From: Thadani, Mohan
Sent: Wednesday, June 11, 2014 10:02 AM
Cc: Wood, Kent; Jackson, Christopher
Subject: RE: MILLSTONE POWER Station, Unit 2-Draft Request for Additional Information.

DOMINION NUCLEAR CONNECTICUT INC.
MILLSTONE POWER STATION, UNIT 2
DRAFT REQUEST FOR ADDITIONAL INFORMATION IN SUPPORT OF
PROPOSED TECHNICAL SPECIFICATION CHANGES FOR SPENT FUEL STORAGE.
DOCKET NO. 50-336 (TAC NO. MF0435)

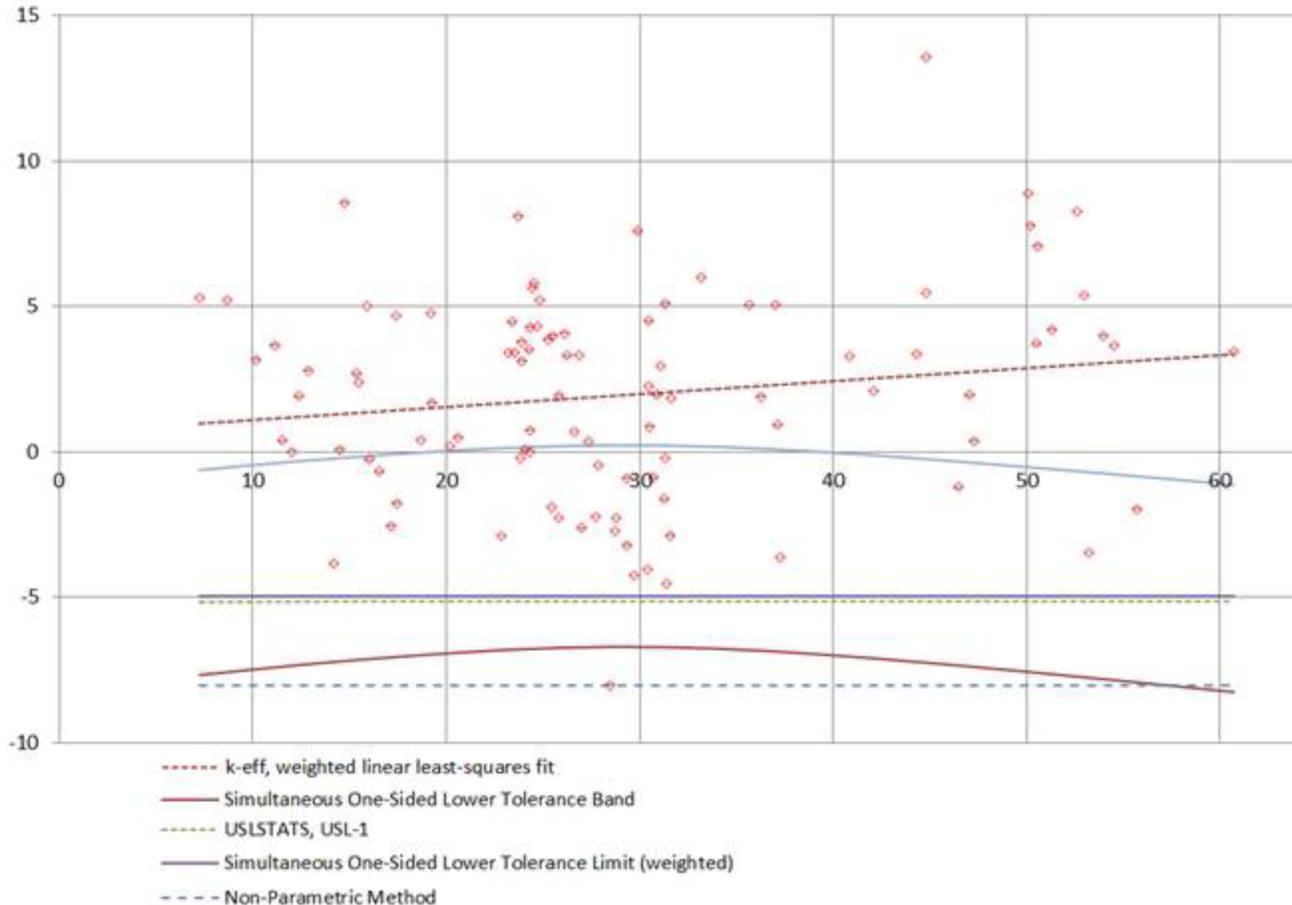
- d. The 4.55% adopted for burnup worth uncertainty does not appear to have 95/95 statistical basis. Figure 3.1-2 plots the values calculated by the licensee for the burnup worth uncertainty.

First, it is not appropriate to extrapolate outside the data points (i.e. below 7.4 GWd/MTU and above 60.7 GWd/MTU). Further, statistical analysis of the data should be used to set the 95/95 uncertainty. For data with a trend, the 95/95 uncertainty should increase near the edges of the data and within the range when the data is sparser. The figure below demonstrates a more statistically defensible uncertainty analysis.

Use of the simultaneous one-sided lower tolerance limit is not appropriate because it assumes that there is no burnup dependent trend. Use of the more appropriate simultaneous one-sided lower tolerance band yields uncertainty values significantly larger than both the commonly used Kopp letter 5% of the decrement value and the 4.55% value proposed by DOMINION. The non-parametric method does not rely on the normality of distribution. The linear least squares fit, tolerance limit, tolerance band and non-parametric analyses were performed using techniques adapted from NUREG/CR-6698. Note that the student's t score for the slope of the fit indicates that there is a 92 % probability that the slope is non-zero and the F test based on the correlation coefficient indicates that there is an 84% probability that the fit is better than random.

Considering items a. through e., the licensee should review and revise the fuel depletion analysis bias and uncertainty and the burned fuel criticality analysis presented in Ref. 2.
